Three Mile Island Nuclear Station, Unit 1
Facility Operating License No. DPR-50
NRC Docket No. 50-289

Subject: Technical Specification Change Request No. 335 – Reactor Coolant System Pressure-Temperature Safety Limit

TMI Unit 1 Technical Specification Change Request No. 335

Markup of Proposed Technical Specifications and Bases Page Changes

CORE PROTECTION SAFETY LIMIT
TMI-1
FIGURE 2.1-1

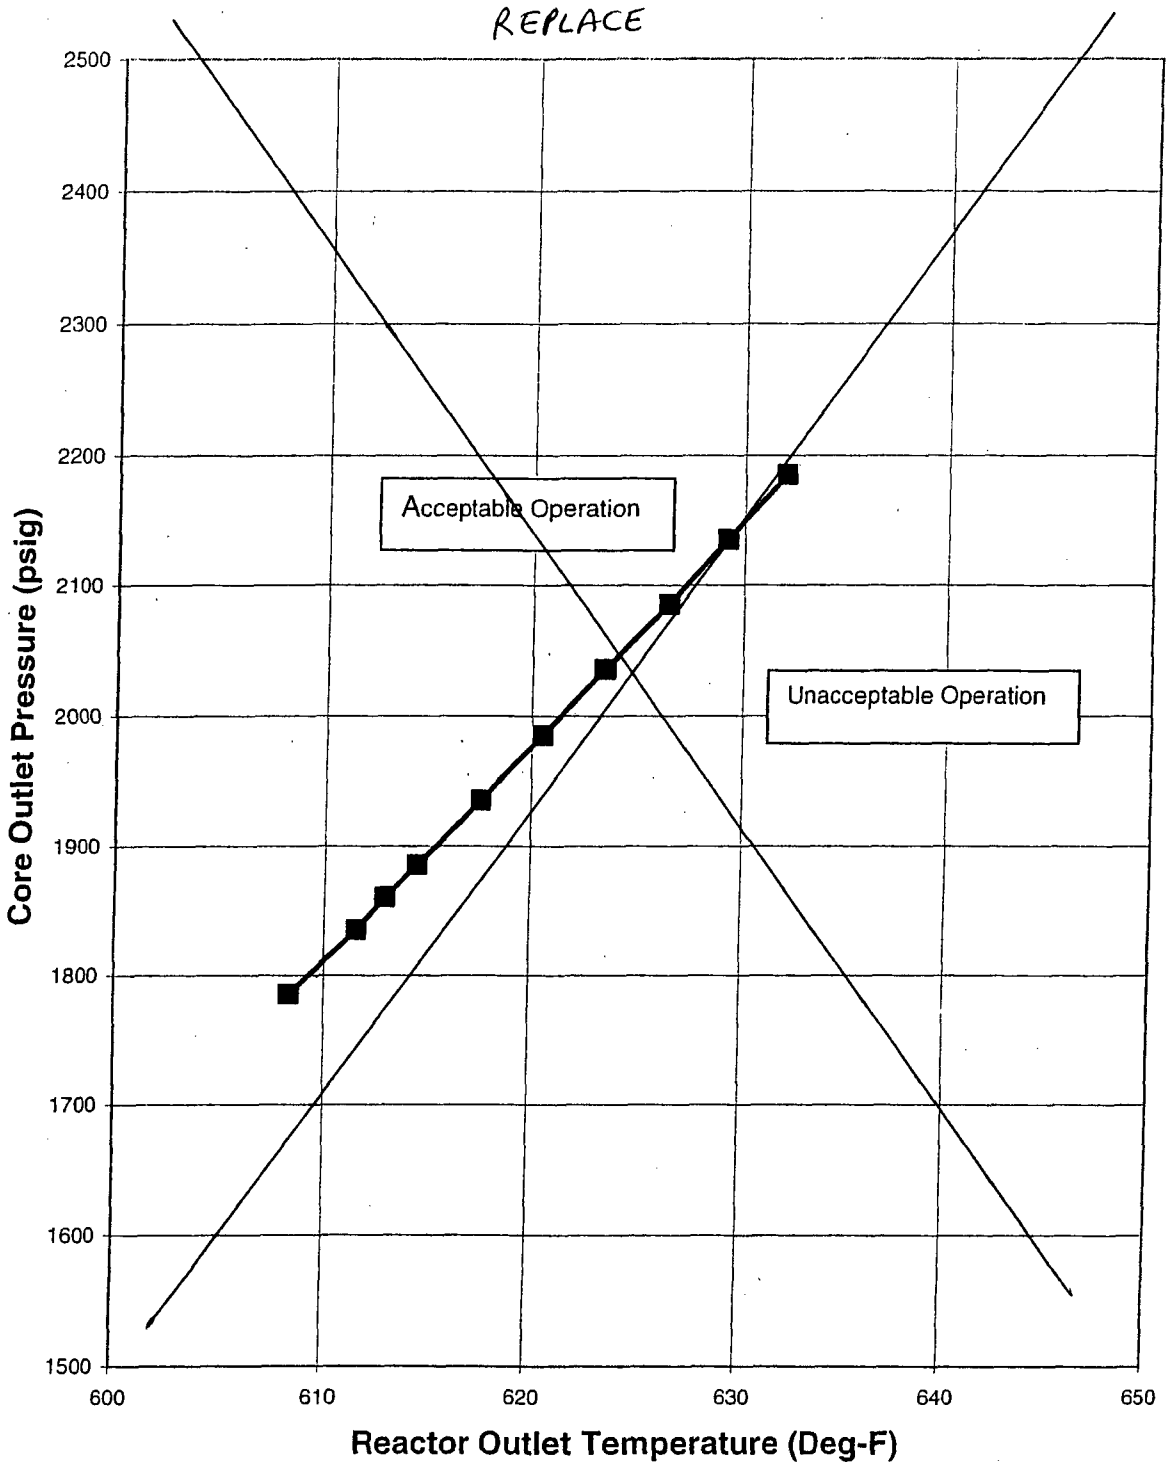
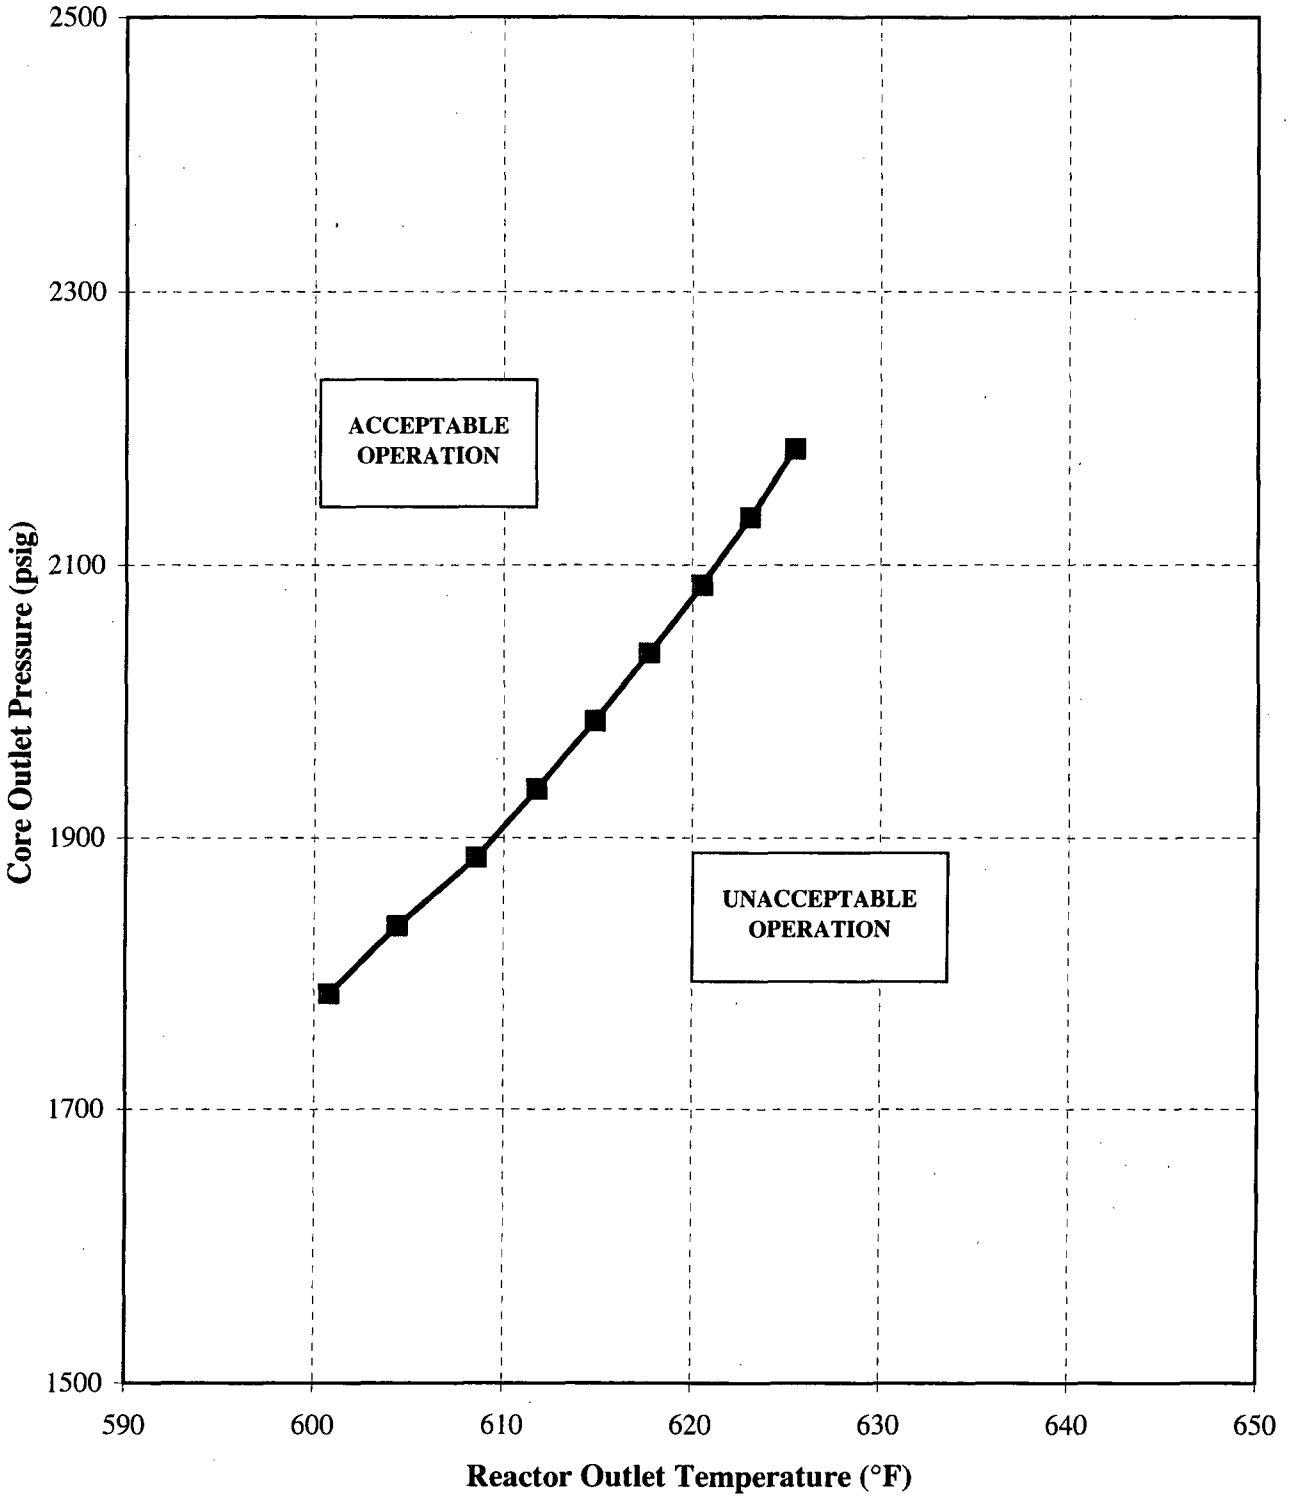
2.2 The Core Protection Safety Limit specified in TS Figure 2.1-1, Core Protection Safety Limit, and Bases Figure 2.1-3, Core Protection Safety Bases, are modified to incorporate a revised limit based on the implementation of the Mark-B-HTP fuel design in Cycle 17.

In conclusion, implementation of the Mark B-HTP fuel design for Cycle 17 requires adoption of a more conservative safety limit curve to maintain the same magnitude of DNB protection. Therefore, TS Figure 2.1-1, Core Protection Safety Limit, requires revision. The change to the core protection safety limit curve requires a related change

CORE PROTECTION SAFETY BASES
TMI-1
FIGURE 2.1-3

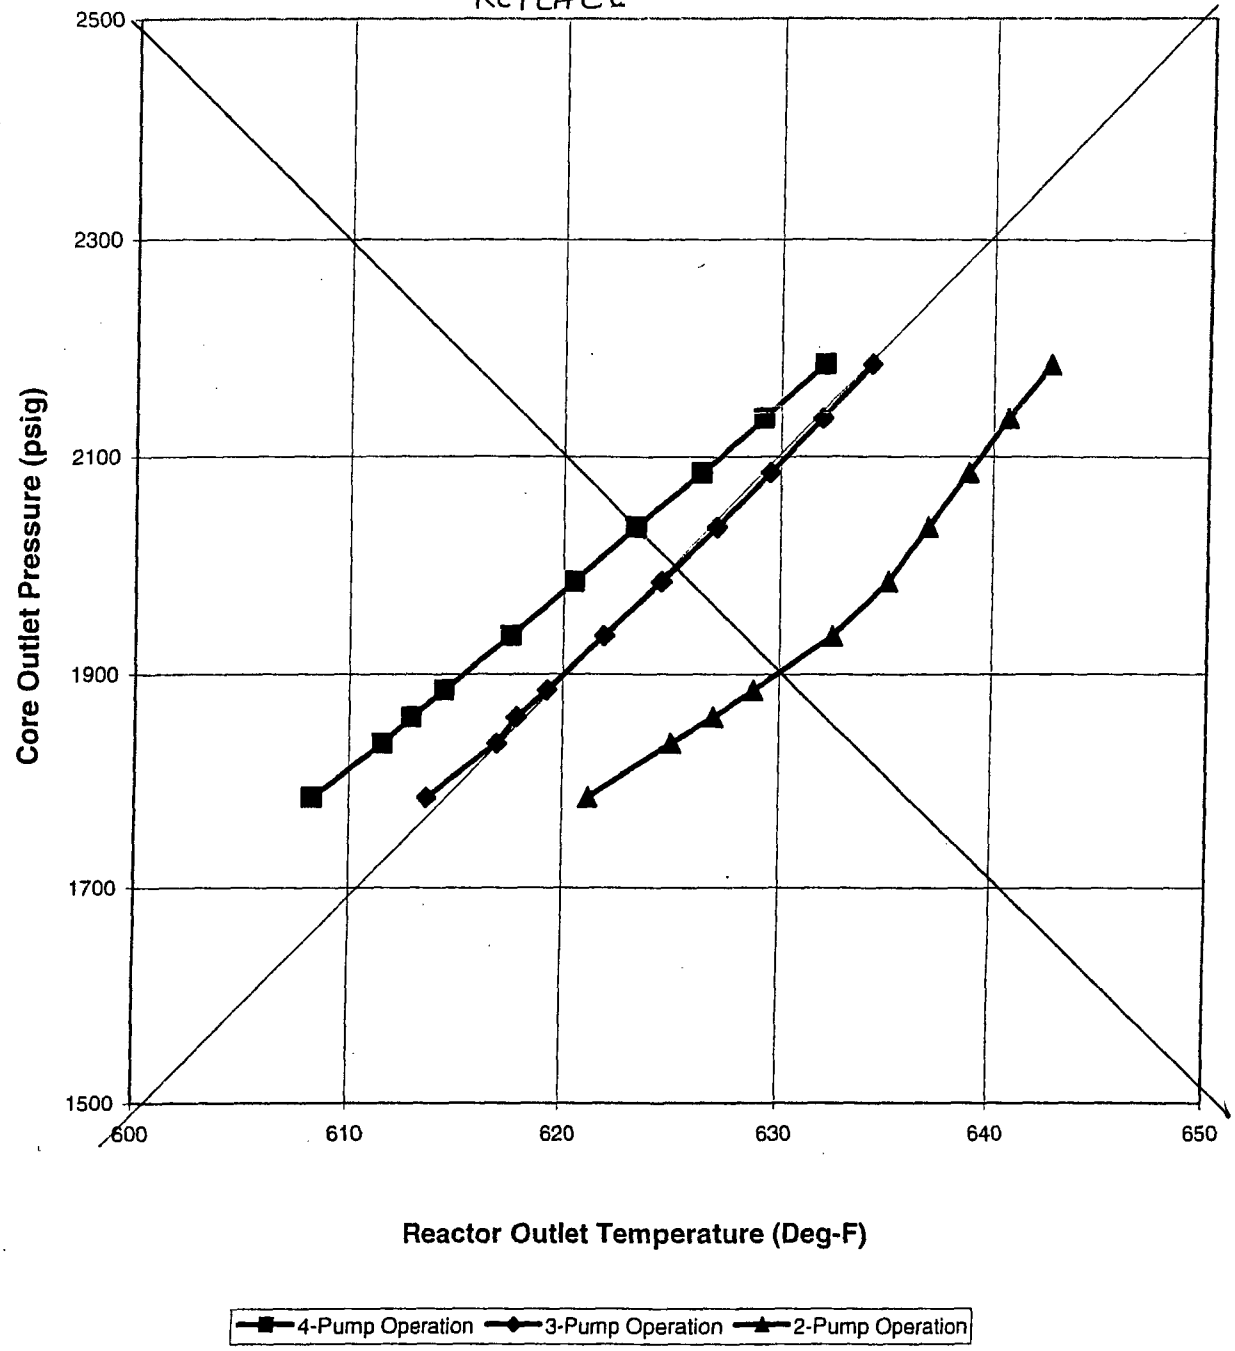
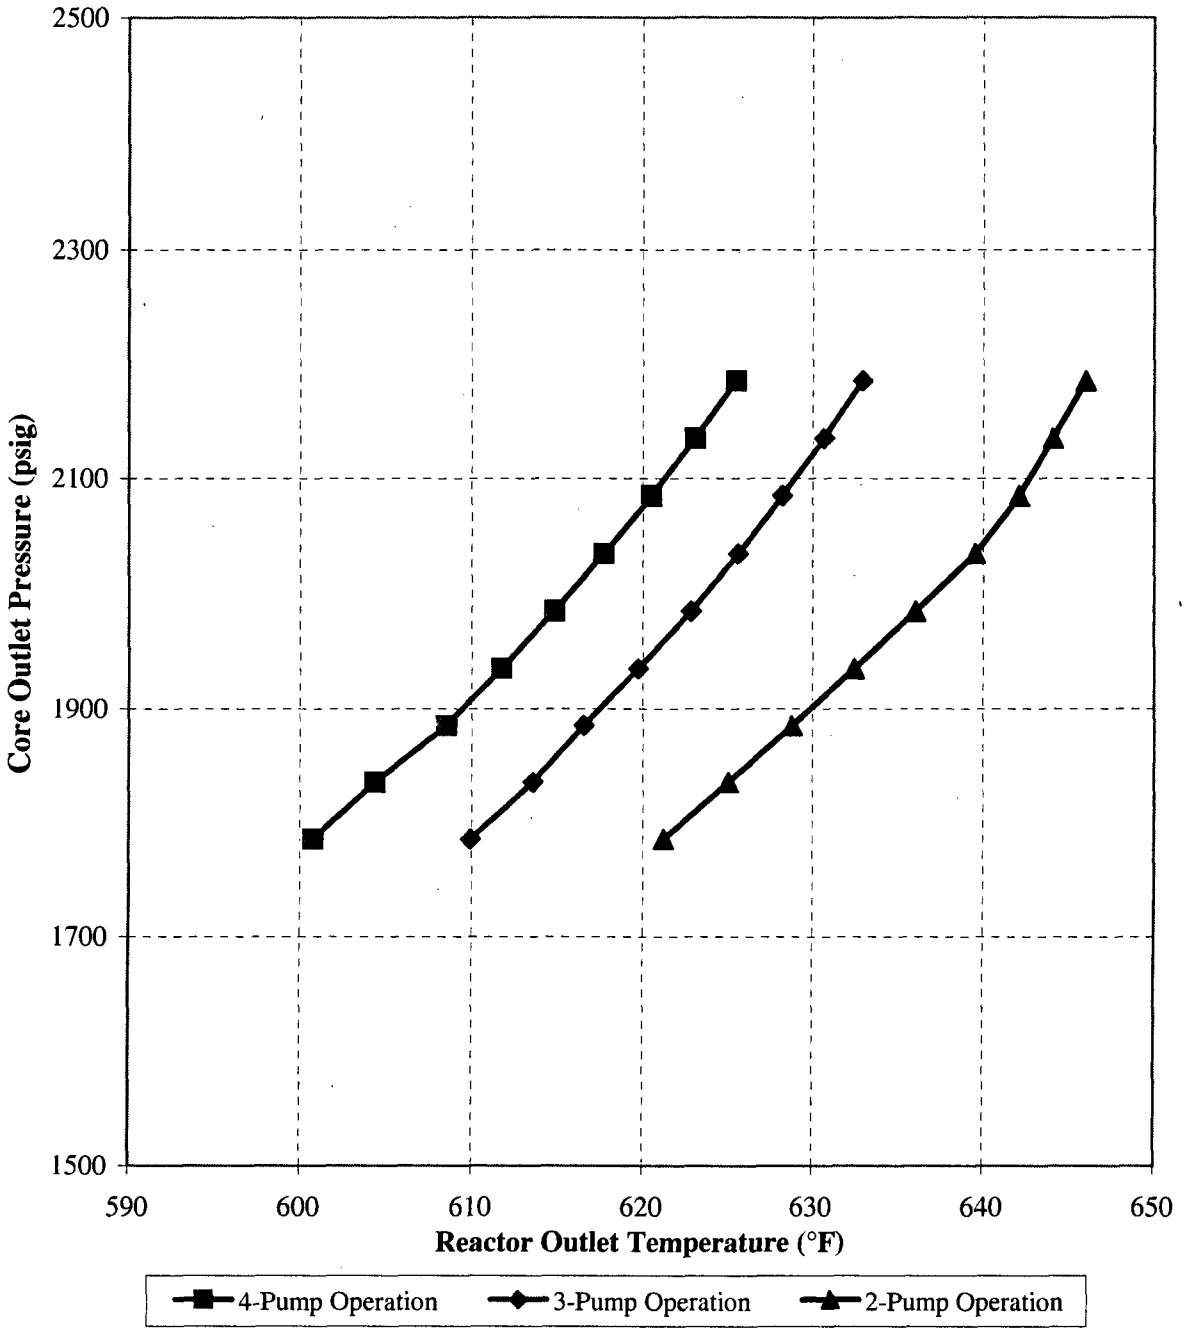
Using a local quality limit ~~of 22 percent (BAW-2), or 26 percent (BWC)~~ at the point of minimum DNBR as a basis for curves 2 and 3 of Figure 2.1-3 is a conservative criterion even though the quality at the exit is higher than the quality at the point of minimum DNBR.

For each curve of Figure 2.1-3, a pressure-temperature point above and to the left of the curve would result in a DNBR greater than the Statistical Design Limit (SDL) [redacted] or a local quality at the point of minimum DNBR less than ~~22 percent (BAW-2) or 26 percent (BWC)~~ for the particular reactor coolant pump situation. Curve 1 is more restrictive than any other reactor coolant pump situation because any pressure/temperature point above and to the left of this curve will be above and to the left of the other curves.

PROTECTION SYSTEM MAXIMUM
ALLOWABLE SETPOINTS
TMI-1
FIGURE 2.3-1

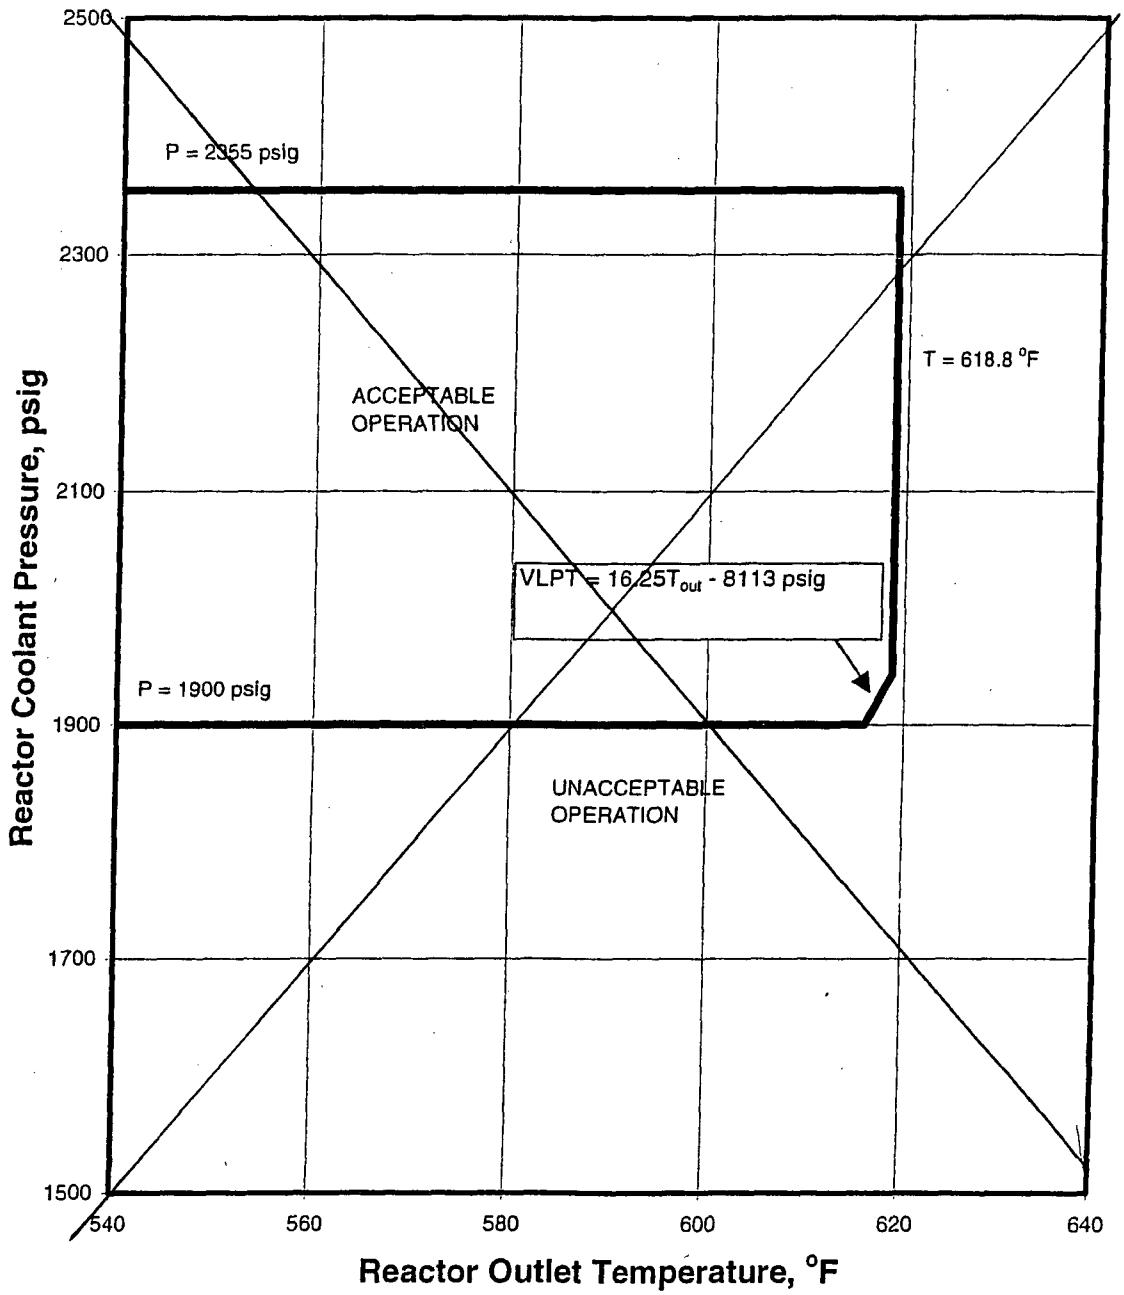
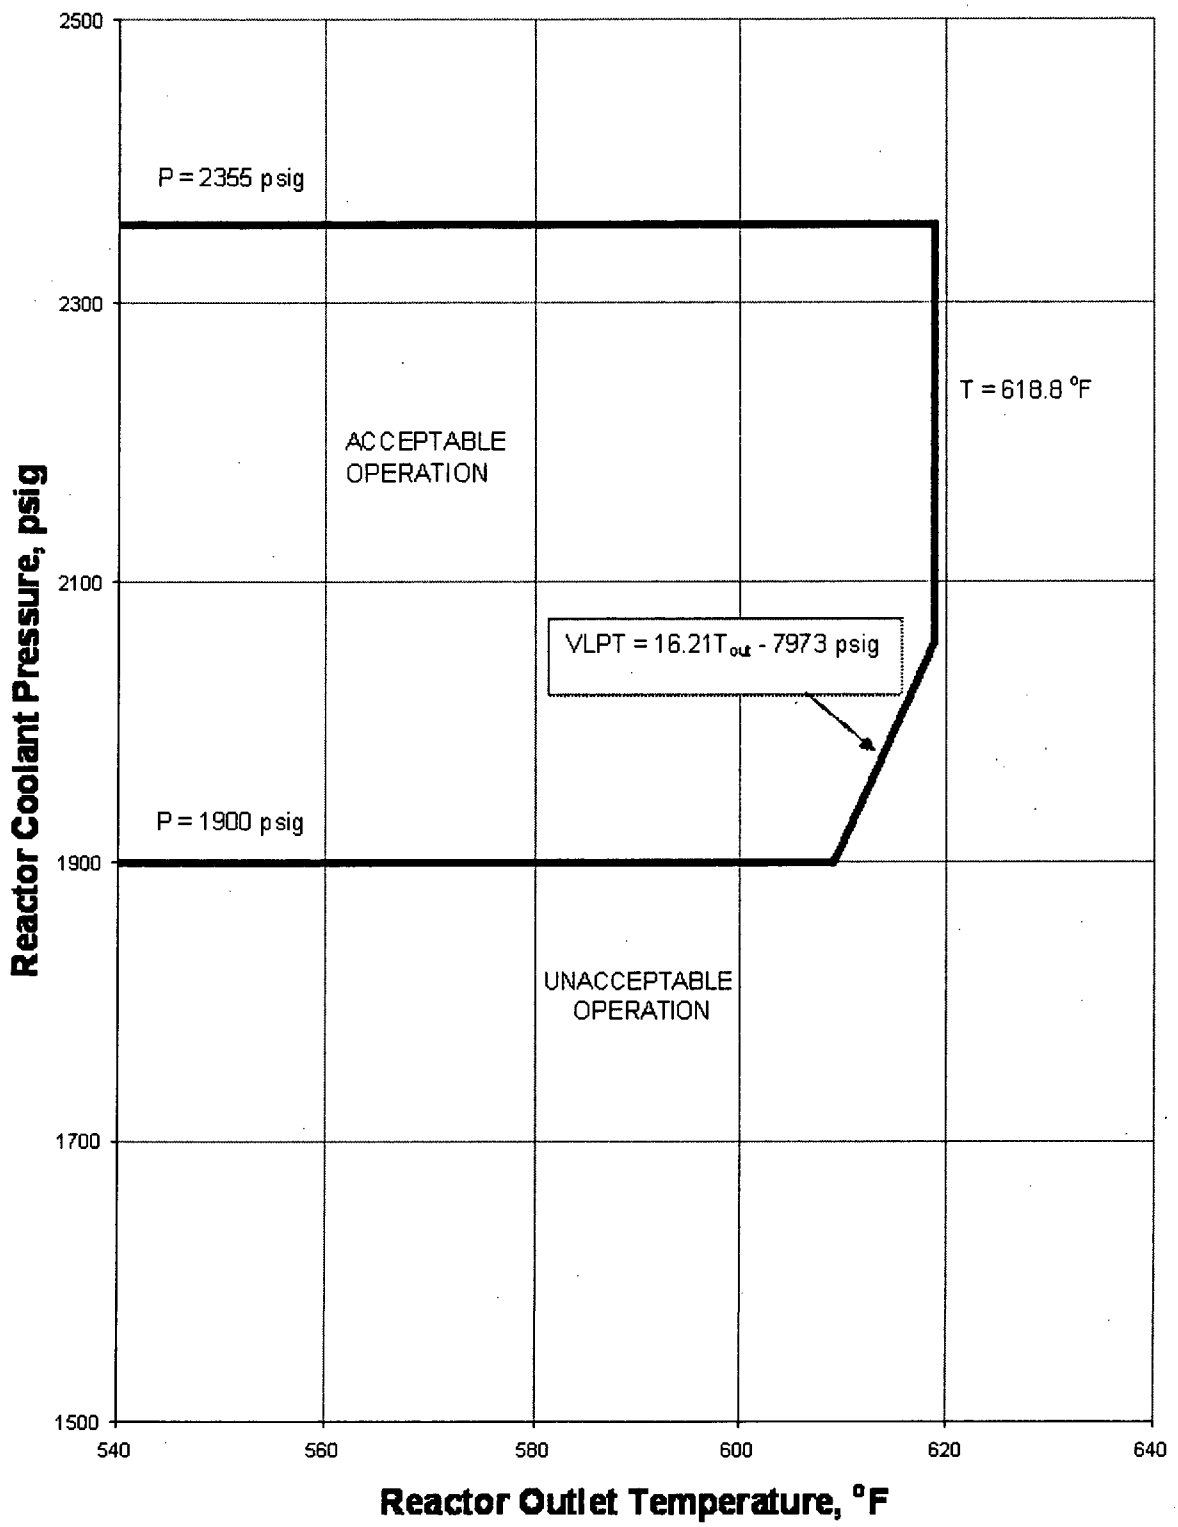
2.3 TS Table 2.3-1, Reactor Protection System Trip Setting Limits, and Figure 2.3-1, Protection System Maximum Allowable Setpoints, are modified to revise the variable low pressure trip setpoint to reflect implementation of the Mark-B-HTP fuel design in Cycle 17.

to the variable low pressure trip setpoint. Therefore, TS Figure 2.3-1, Protection System Maximum Allowable Setpoints, and TS Table 2.3-1, Reactor Protection System Trip Setting Limits, require revision. Variable low pressure trip setpoint surveillance requirements, established in accordance with NRC RIS 2006-17, "NRC Staff Position on the Requirements of 10 CFR 50.36, "Technical Specifications," Regarding Limiting Safety System Settings During Periodic Testing and Calibration of Instrument Channels," dated August 24, 2006, require the addition of pre-defined acceptance criteria to TS Table 4.1-1, Instrument Surveillance Requirements. The proposed changes to the TMI Unit 1 TS have been established to assure adequate margins of safety are maintained and have been developed in accordance with NRC-approved codes and methodologies. Therefore, the proposed changes do not adversely affect nuclear safety or safe plant operations.
